Diversified Metal Fabricators Service Bulletin SB 2078

Title	RW-1016 Suspension Arm Lock Washer Replacement
Document No.	SB2078 Rev A
Issue Date	11/14/2019 (TAM)
Release	General
Units Affected	RW-1016 models (front and rear) with S/N's <u>lower than</u> 46032
Purpose	Reduced potential for suspension separation

Figure 1. RW-1016 Suspension Arm Lock Washer Replacement

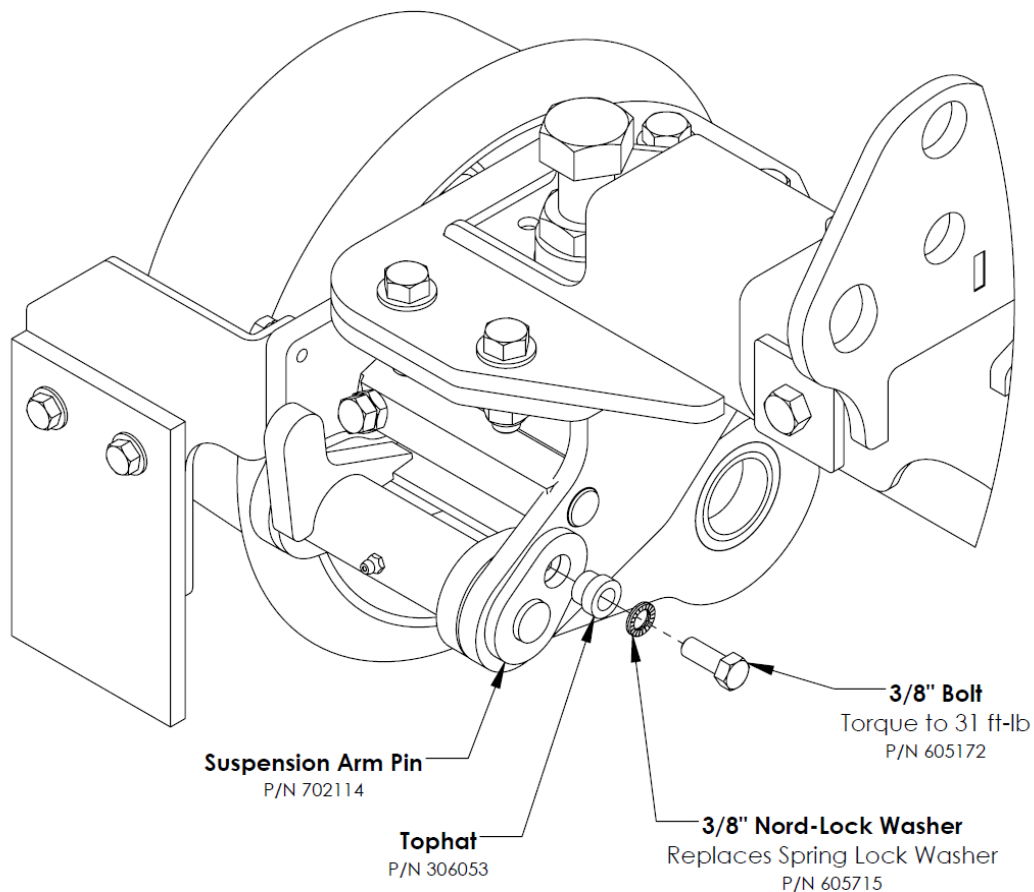
In rare circumstances, the bolt retaining the suspension arm pin may loosen and fall out over time. This may allow the suspension pin to back out, and the lower suspension arm and wheel to separate from the railgear assembly. Replacing the standard spring lock washers under the retaining bolt with upgraded Nord-Lock washers will greatly increase the vibration resistance of retaining bolt.

1. Contact DMF and request QUANTITY 4 of P/N 605715 (NORD-LOCK WASHER, 3/8").
2. Remove the 3/8" bolt retaining the suspension arm pin.
3. Remove and discard the 3/8" spring lock washer.
4. Make sure the "top hat" is reinstalled against the pin head.
5. Reinstall 3/8" bolt using a 3/8" Nord-Lock washer. Nord-Lock washers are a two-piece design, but are held together with adhesive for ease of assembly. Do not separate the washer pairs.
6. Torque 3/8" bolt to 31 ft-lb.
7. Repeat procedure on all RW-1016 suspension assemblies on vehicle.
